Overview: Production error in version 1.0 harnesses; The immobilizer wire (orange/black) is in pin position #4 instead of pin position #5. Although an effort to correct the issue was made, some quantity of harnesses did get shipped before the issue was spotted. We are advising to inspect the harness BLADE connector before attempting to install harness or program the module. This issue is not known to affect the version 2 harnesses, which require no modification.

Overview: Early versions of the FTI-STP1 harness require modification for **automatic transmission (AT)** applications, some of the product was able to be modified before release, but a small quantity was released without modification.

FTI-STP1: Installation and Configuration Notes

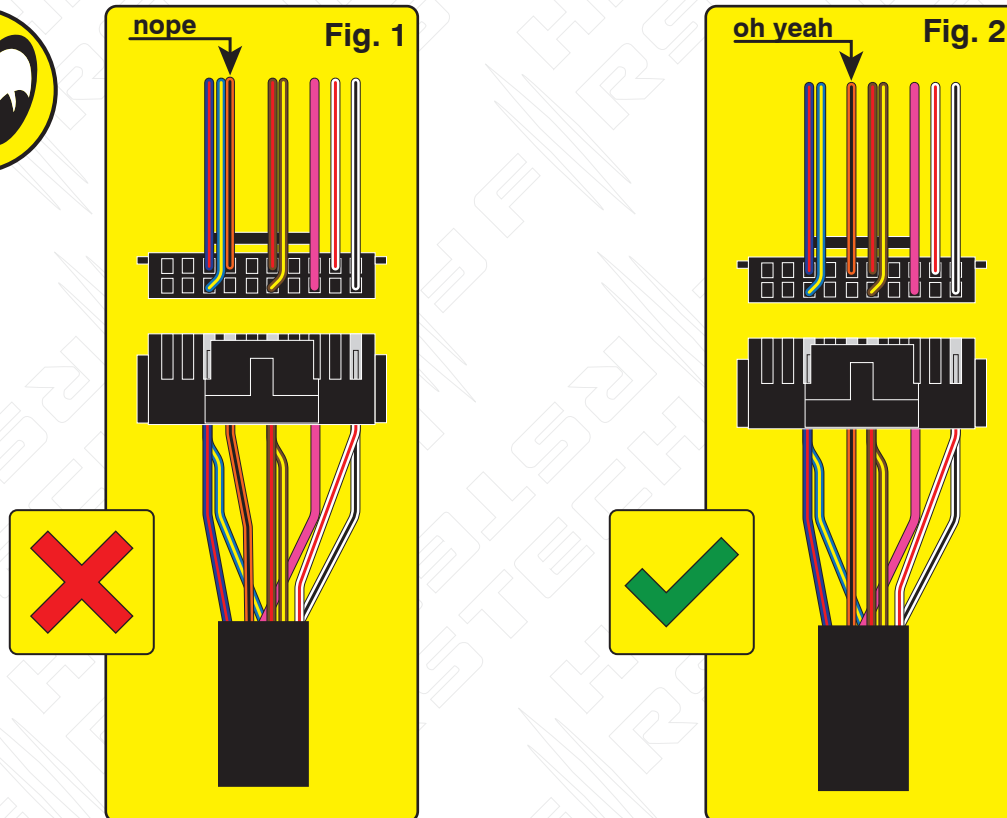
Issue: Module fails to program correctly to vehicle, does not allow the vehicle to be remote started.

Correction: Step 1.) Locate the orange/black wire and confirm whether it is positioned as illustrated in Fig. 1 or Fig. 2. If the wire is as illustrated in Fig.1, proceed with Step 2 through 5 and complete the repair procedure outlined, if the wire is as illustrated in Fig. 2, correction is not necessary, proceed with harness installation and module programming.

Step 2.) Using a pick, lightly depress the catch that secures the terminal in the housing then remove the wire and terminal from the housing.

Step 3.) Using a fine tip razor or utility knife, insert the blade beneath the terminal catch and raise it slightly, so that it can be reused to secure the terminal when reinserted into the BLADE connector housing.

Step 4.) Refer to Fig. 2 for correct position of the orange/black wire (next to brown/red) then reinsert the terminal, pressing lightly until the catch 'snaps' into place, securing the terminal in the connector housing.

Step 5.) The repair is complete, proceed with installation and programming.

MODIFICATION REQUIRED FOR A/T APPLICATIONS, ONLY WITH v 1.0 HARNESS

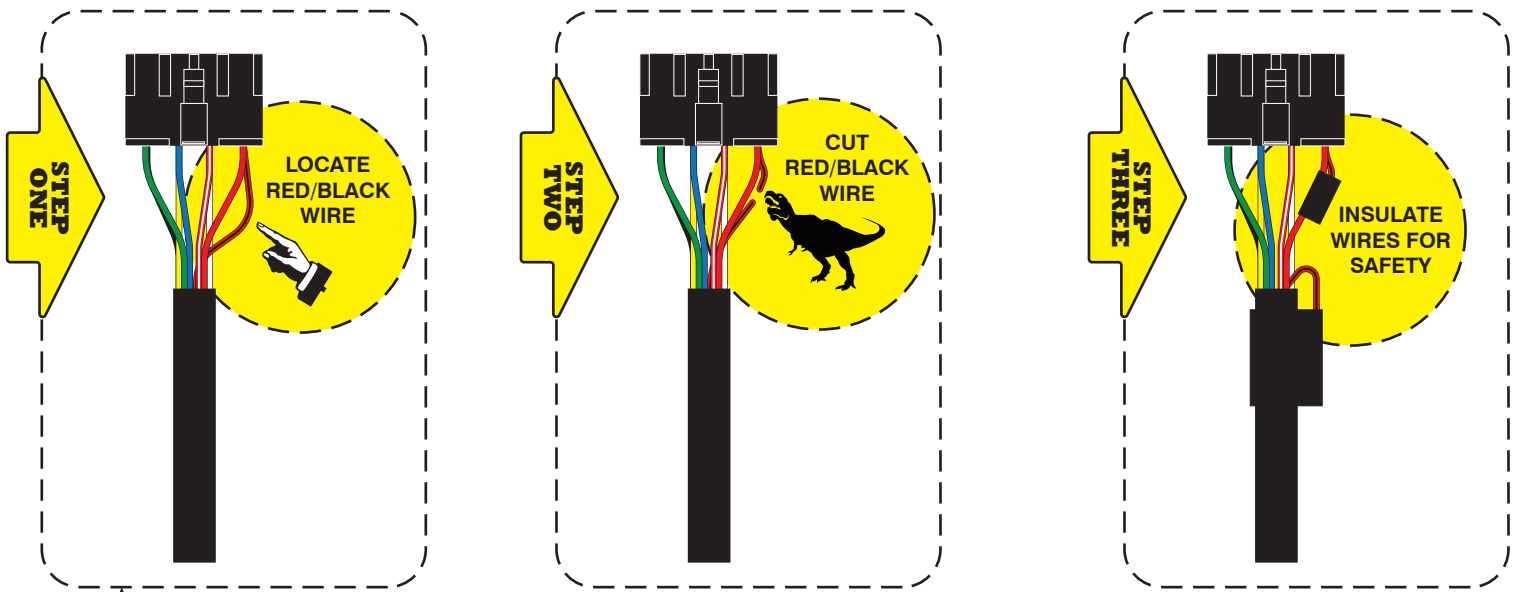
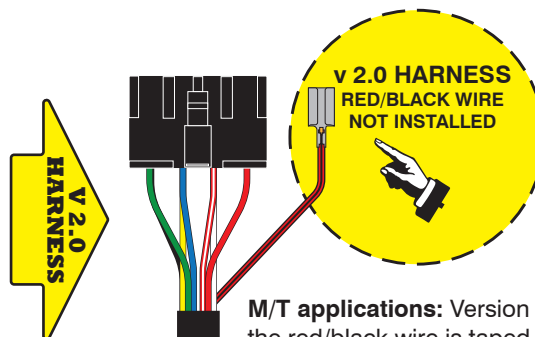
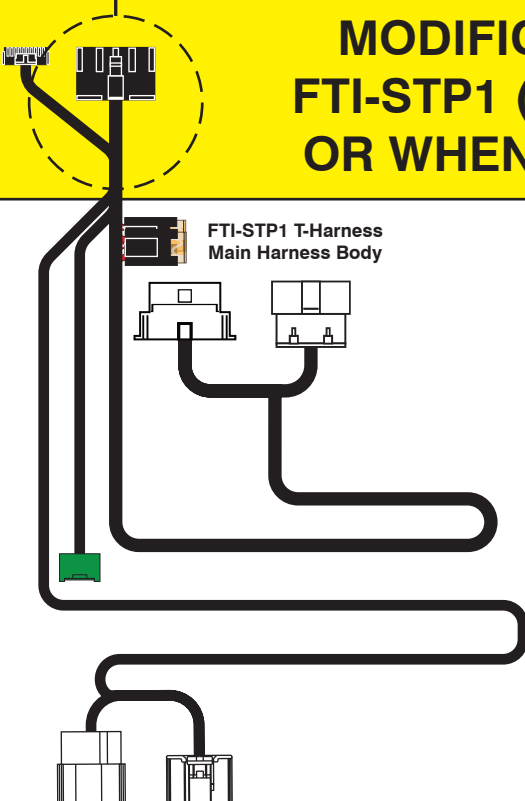
Issue: The FTI-STP1 T-harness has been designed to be compatible with A/T (automatic transmission) & M/T (manual transmission) applications, but due to an oversight in early production runs, the selection was defaulted to M/T mode.

Using a harness configured for an M/T application, in an A/T equipped vehicle, could result in vehicle module damage, it is advised that the harness be returned to A/T mode before installation in vehicles equipped with an automatic transmission.

Correction: Locate the **red/black (+ Clutch)** wire provided in the CN1 connector of the main harness assembly. Cut the **red/black** wire, either flush to the CN1 connector, or leaving enough wire exposed so that you can insulate and secure the ends of the wire that remain after cutting. Insulate each of the remaining ends of the **red/black** wire and secure to prevent any possibility of a short circuit. **If the red/black wire has already been disconnected, no further modification is required for A/T applications**

M/T applications: Version 2.0 harness, the red/black wire is taped to the main harness when shipped, and must be installed in the CN1 connector when installed.

A/T applications: Leave the red/black wire taped to the harness, it is not required for A/T applications
